REMARKS

Claims 23-25, 27, 29-33, 35-37, 39-43, and 45-50 are currently pending based on the amendment herein. Claims 26, 28, 34, 38, and 44 have been cancelled. Claims 23, 27, 33, 35, 37, 39-43, and 45 have been amended. Claims 46-50 are new

FIG. 6

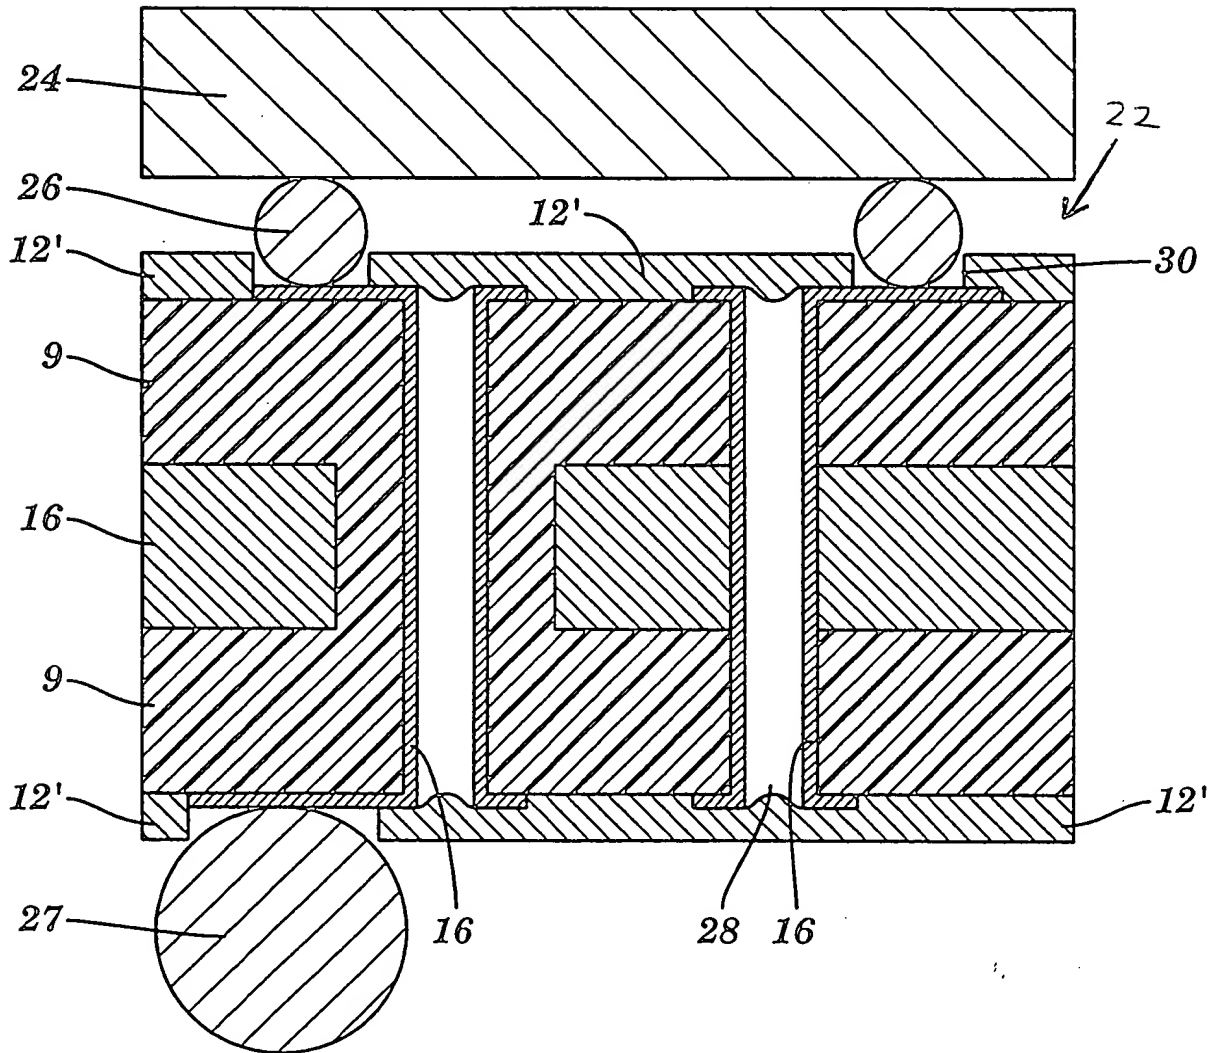
The Examiner objected to the drawings as allegedly “failing to comply with 37 CAR 1.84(p)(5) because they do not include the following reference sign(s) mentioned in the description: 22 (page 19, line 19 first mentioned). A proposed drawing correction or corrected drawings are required in reply to the Office action to avoid abandonment of the application. The objection to the drawings will not be held in abeyance.” In response, Applicants amended FIG. 6 to show reference numeral 22.

In the Specification, the paragraph beginning on page 19, line 19 is amended as follows:

Fig. 6 shows an integrated circuit chip carrier 22 that includes the coated filled body 9. The structure of the chip carrier 22 is generally known to those of ordinary skill in the art and although the precise form may vary, the chip carrier 22 of the present invention generally includes the following components: (1) dielectric layers including filled bodies 9; (2) electrically conductive layers 16; (3) plated through holes 28; (4) solder chip connectors 26; (5) ball grid array solder connector 27; (6) electrically conductive pads 30; [(7) integrated circuit chip 24;] and ([8]7) thermosetting resin 12' now used as a solder mask. The integrated circuit chip 24 is coupled to the chip carrier 22 through the solder connectors 26.
